NUCLEAR REGULATORY COMMISSION

Title: Advisory Committee on Reactor Safeguards
US-APWR Subcommittee

Date: Monday, June 7, 2010

➤ 1) Change of χ/Q for 4-30 days

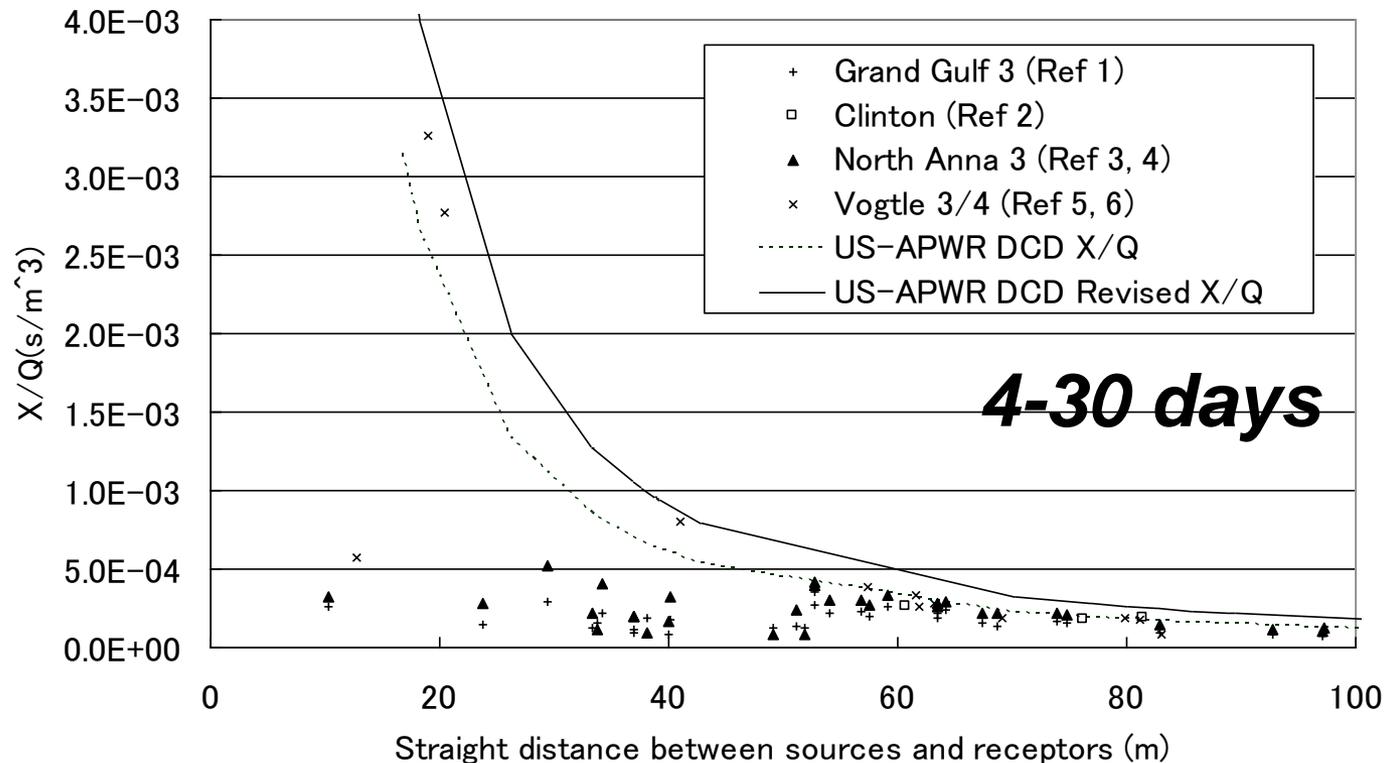
20 This question is for staff finds that 4-
21 to-30 days chi/Q value for the MCR and the TSC were
22 not bounding for three out of the four sites; North
23 Anna, Clinton, Grand Gulf and Vogtle. And they are
24 not representation of the U.S. The staff suggested
25 that 4-to-30 days chi/Q value increase to ensure they

- 1) Change of χ/Q for 4-30 days
- RAI NO.562-4427 REVISION 2, 4/23/2010
 - QUESTION NO. 02.03.04-9 a.
 - The staff found that the 4-30 days χ/Q values for MCR and TSC were not bounding for 3 out of the 4 sites (North Anna, Clinton, Grand Gulf and Vogtle), and they were not representative of a reasonable number of US sites. The staff suggested that the 4-30 days χ/Q values increase to ensure they bound a reasonable number of sites.

- 2) Change of source locations
- ANSWER

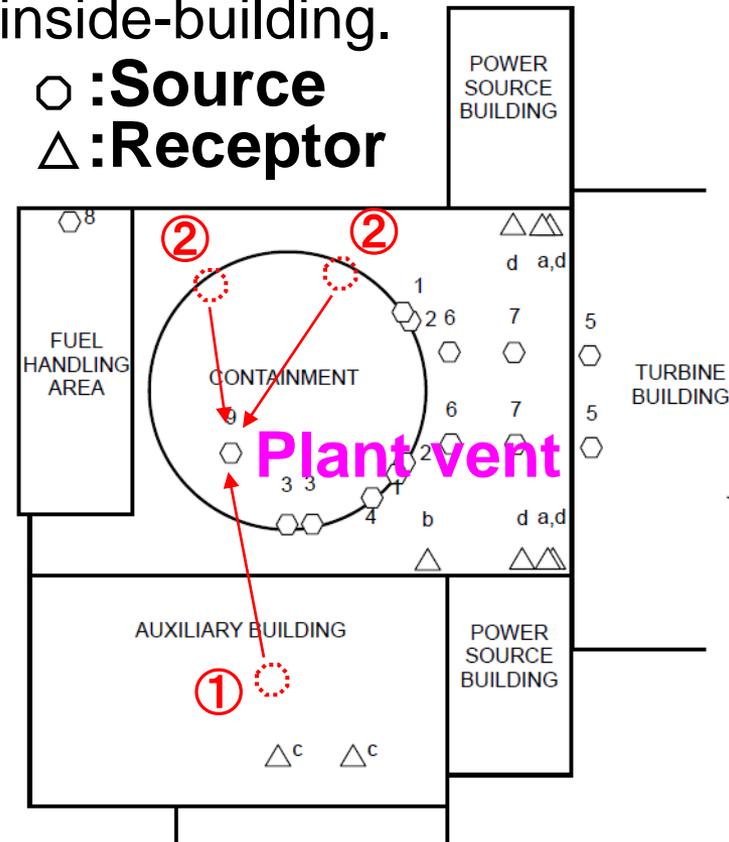
18 This question is posed some pathways
19 where the source location is inside the building,
20 imply indoor transport and dispersion. The ARCON96
21 are not appropriate for modeling indoor transport and
22 dispersion. If the reactivity in the spilled reactor
23 coolant is assumed to be discharged to the atmosphere
24 from the plant vent stack for the purposes of
25 modeling the MCR dose, then the plant vent should be

- **2) Change of source locations**
- **OPEN ITEMS RSAC 2.3.4, 2/13/2009**
 - Open Item 02.03.04-1
 - Some pathways, where the source location is inside the building, imply indoor transport and dispersion. The ARCON96 are not appropriate for modeling “indoor” transport and dispersion. If the reactivity in the spilled reactor coolant is assumed to be discharged to the atmosphere from the plant vent stack for the purposes of modeling MCR doses, then the plant vent should be identified as the release pathway.

6 So two accidents assumed here occurred
7 inside a building at location 1 and 2. But the
8 radioactive materials goes through inside building to
9 the plant vent and then it's discharged to the
10 atmosphere from the plant vent. So source location
11 should be plant vent. This is the realistic
12 situation.

- Some source locations of the following accidents are changed to a plant vent from an inside-building.

Figure 15A-1 Site Plan with and Intake Locations

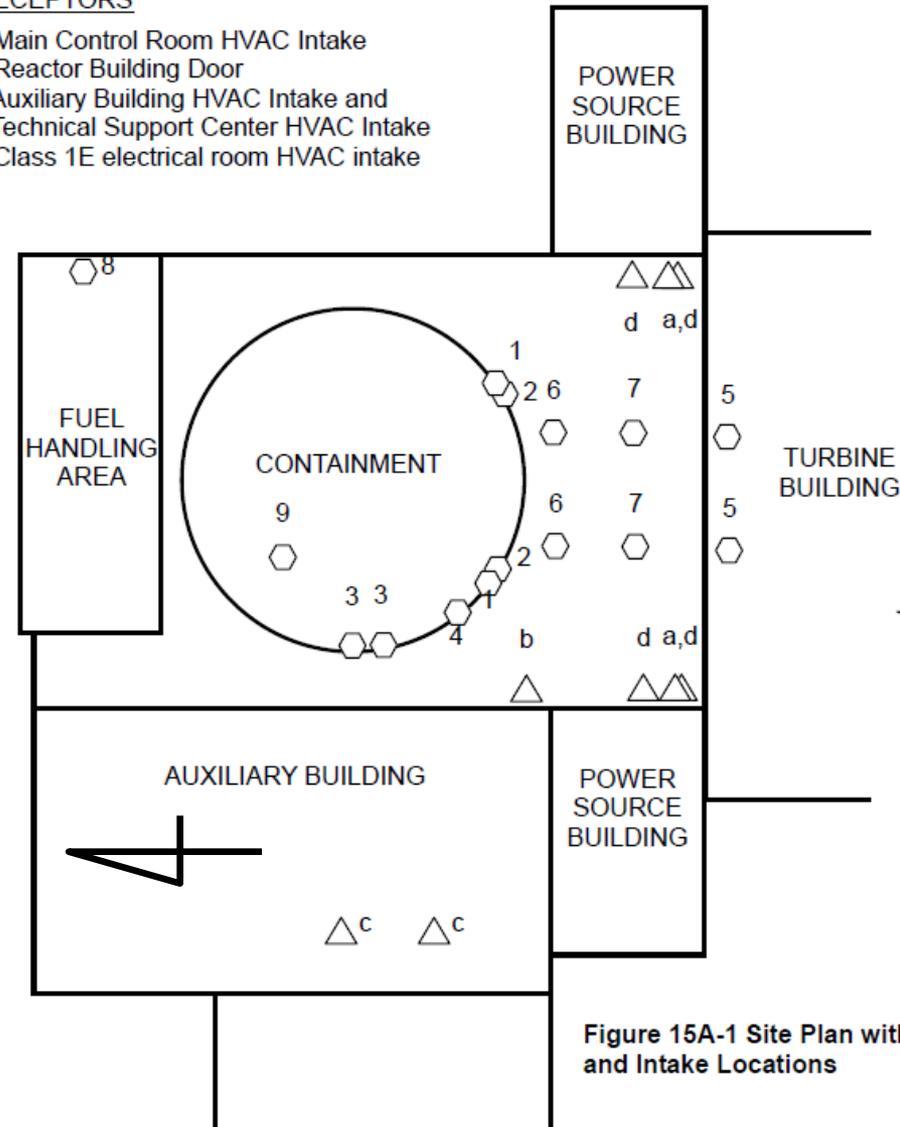
3 This question is DCD Tier 1 Table 2.1-1
4 and DCD Tier 2 Table 2.0-1 identify inleakage
5 locations for some, but not all, of the postulated
6 accidents and anticipated operational occurrences.
7 COL applicant should be directed to evaluate chi/Q
8 value for each inleakage location for each accident
9 release point and compare the resulting bounding
10 chi/Q value with the corresponding key site parameter
11 values.

1 The next slide is Figure 1. This is
2 layout of all locations of source and receptors. So
3 symbol of the circles indicated the source location.

- **3) Description of additional information**
- **ANSWER**
- **The following information is described for COL applicants:**
 - All combinations of the sources and receptors for MCR and TSC, as well as the shortest distance combination used in the dose calculation
 - Source locations for each accident in Table 1
 - Locations of source and receptor is shown in Figure 1

➤ 1) Setpoints – Allowable Value Calculation

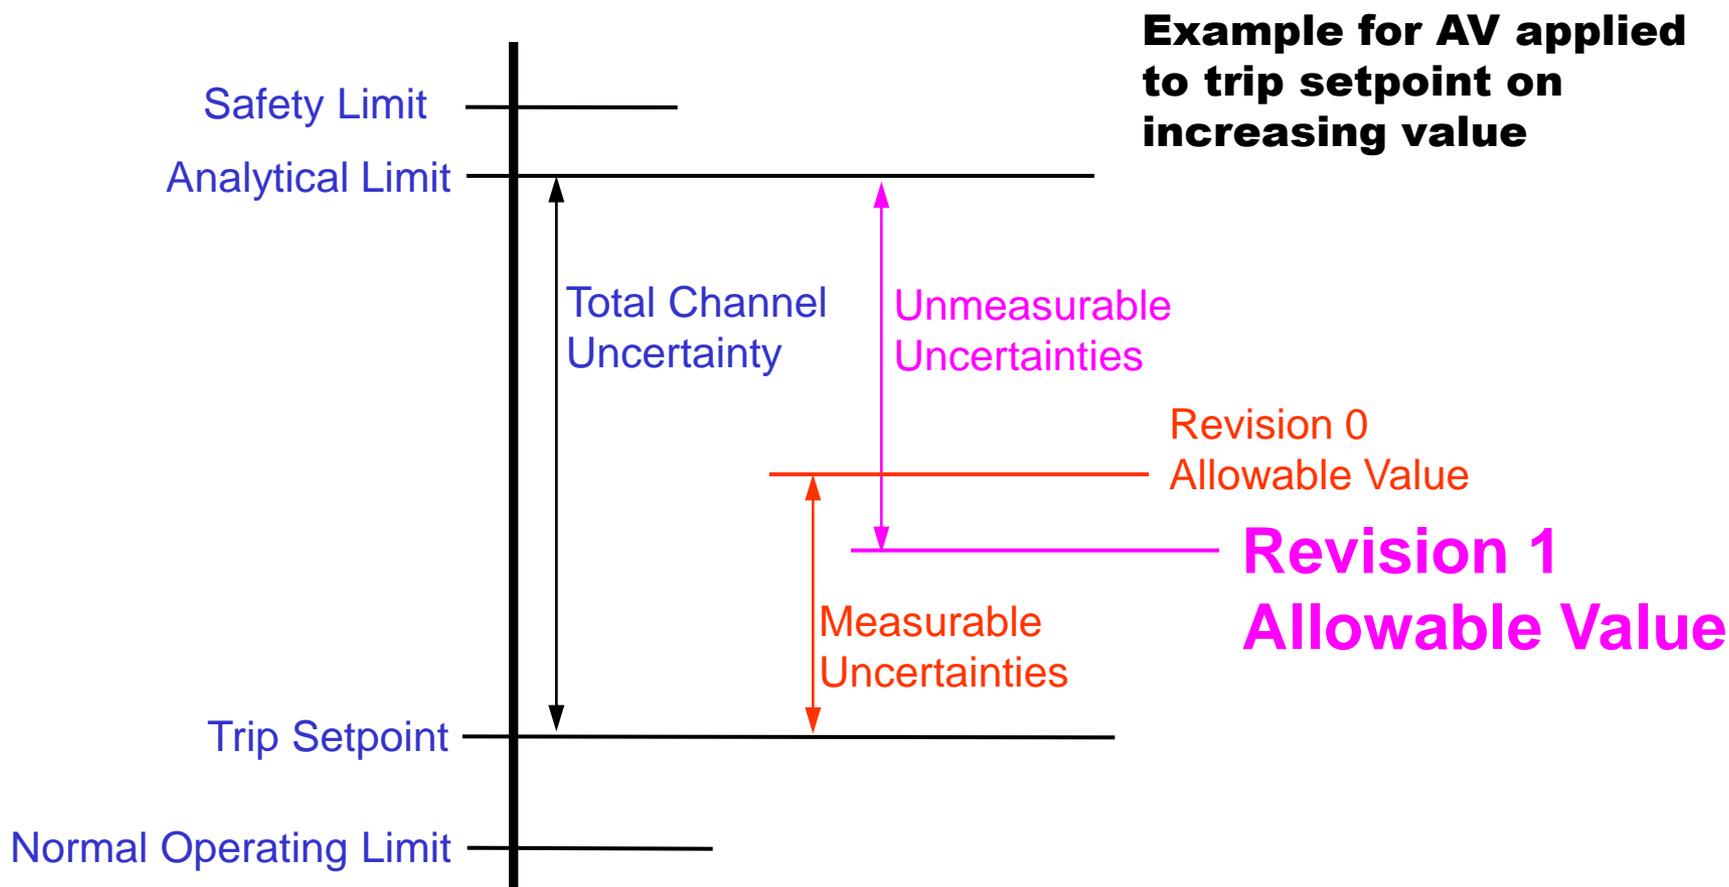
- Allowable Value (AV) is the acceptance criteria for channel measurements during periodic surveillance
- NRC staff correctly commented that MHI's method of calculating AV does not provide sufficient allowance for those uncertainties not measured during the test.
